Docket Number:	12-AFC-02
Project Title:	Huntington Beach Energy Project
TN #:	202701
Document Title:	Letter Re: Coastal Commission's 30413(d) Report for the Proposed AES Southland, LLC HBEP AFC, dated July 14, 2014
Description:	From California Coastal Commission
Filer:	Alicia Campos
Organization:	California Energy Commission
Submitter Role:	Commission Staff
Submission Date:	7/15/2014 8:11:56 AM
Docketed Date:	7/15/2014

CALIFORNIA COASTAL COMMISSION

RE: Coastal Commission's 30413(d) Report for the Proposed AES Southland, LLC Huntington Beach Energy Project – Application for Certification #12-AFC-02

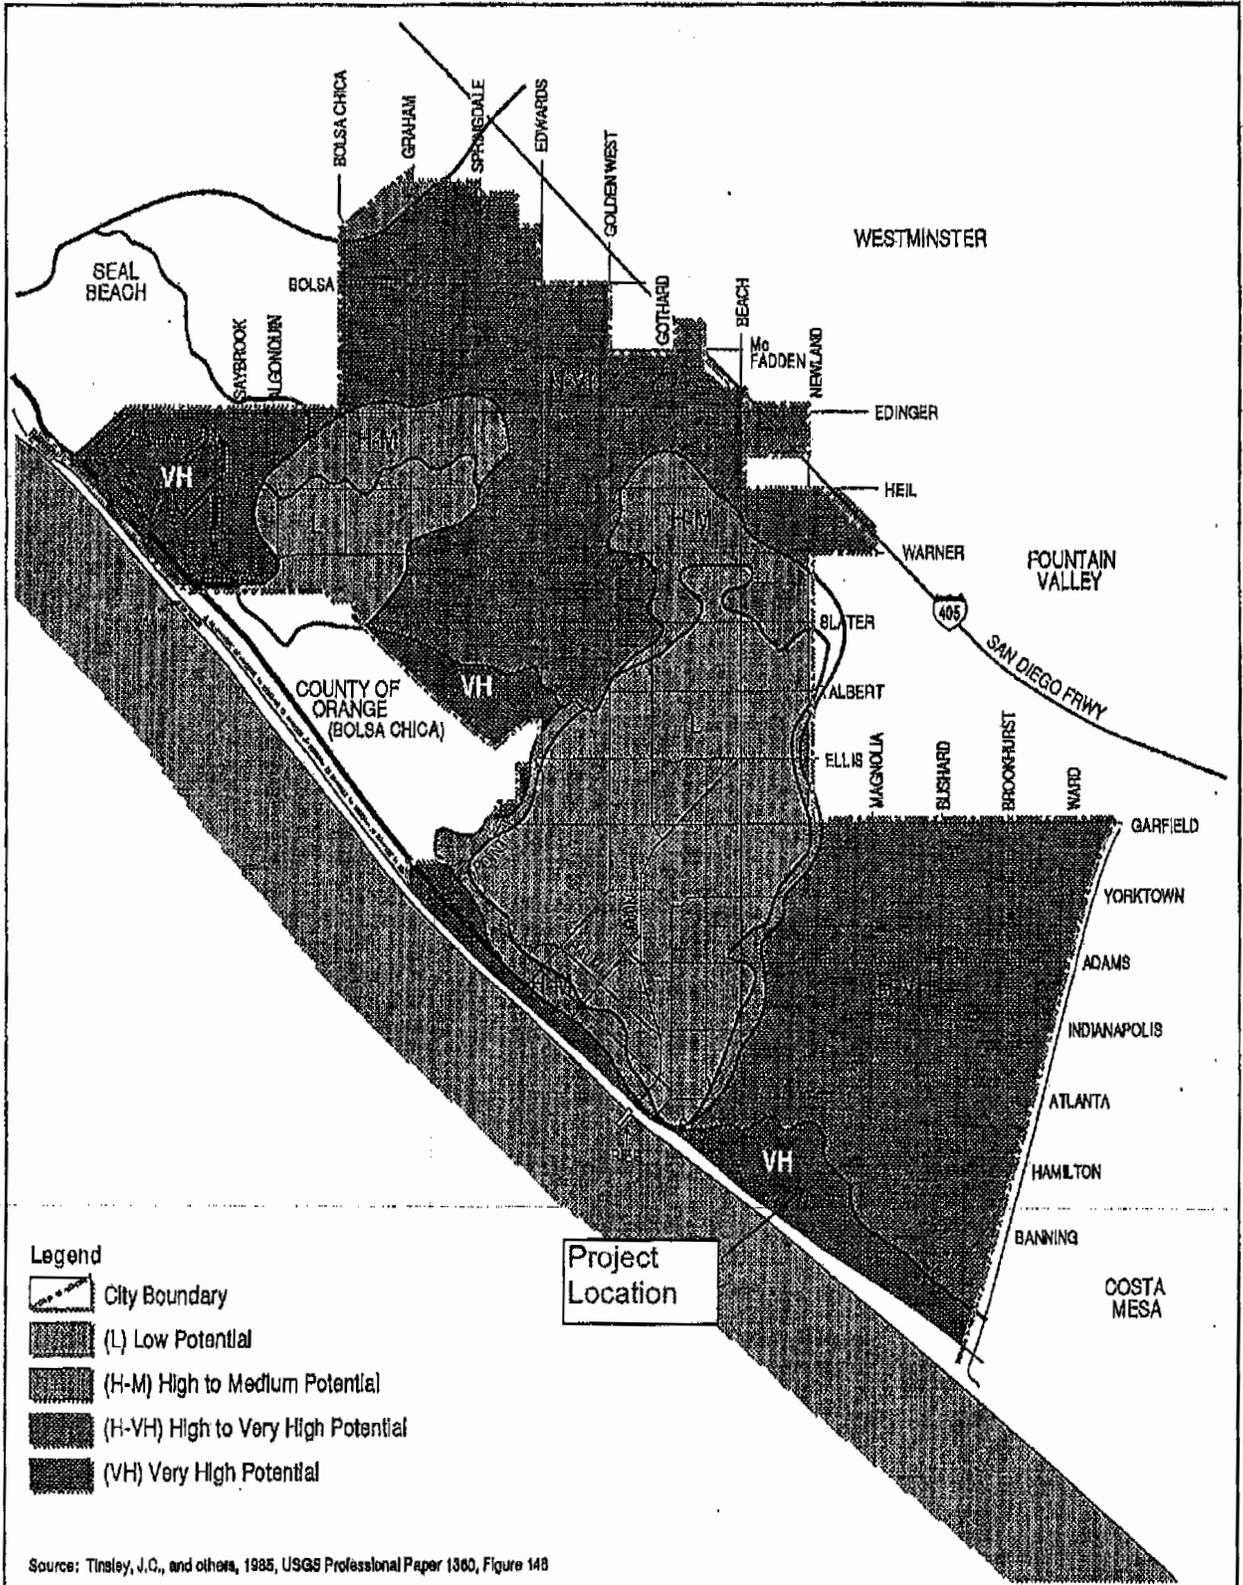
The proposed project site is within an area the City has designated as having “Very High” liquefaction potential (see **Exhibit 12 – Map of Liquefaction Potential in Huntington Beach**). The FSA notes that conditions within the power plant site are likely conducive to liquefaction, though less so for lateral spread. As noted above, the power plant site’s liquefaction and lateral spread hazards are likely to be exacerbated by the increased surface and groundwater levels associated with predicted sea level rise during the HBEP facility life. The City additionally notes in its Environmental Hazards Chapter that earthquake intensities are likely to be higher in liquefaction-prone areas than in nearby non-liquefaction prone areas. It is not clear whether the range of ground motions noted above incorporate this potential for higher intensities.

construction of stone columns or buttresses, placement of sheet piles, excavation, as well as other measures, any of which could change the project's anticipated coastal resource effects and its conformity to Coastal Act and LCP policies. Placement of buttress walls, for instance, could alter or reduce groundwater flow beneath the site and affect nearby wetlands, while extensive excavation could require significantly increased truck traffic and adversely affect public access to the shoreline. Additionally, given the site's potential for relatively severe ground motion, results of the upcoming studies could show that the facility will require extraordinary means of construction to ensure its stability. We are therefore recommending the following modifications, as shown in ~~strikethrough~~/**bold underline** below:

“A Soils Engineering Report as required by Section 1803 of the California Building Code (CBC 2013), shall specifically include laboratory test data, associated geotechnical engineering analyses, and a thorough discussion of seismicity; liquefaction; dynamic compaction; compressible soils; corrosive soils; and tsunami. In accordance with CBC 2013, the report should also include recommendations for ground improvement and/or foundation systems necessary to mitigate these potential geologic hazards, if present. **If the analyses or recommendations show that the project will cause greater or more significant adverse effects to coastal resources than identified and evaluated in the Presiding Member's Final Decision for this AFC, the project owner shall submit the analyses and recommendations for additional public review to be conducted by the CEC staff.**”
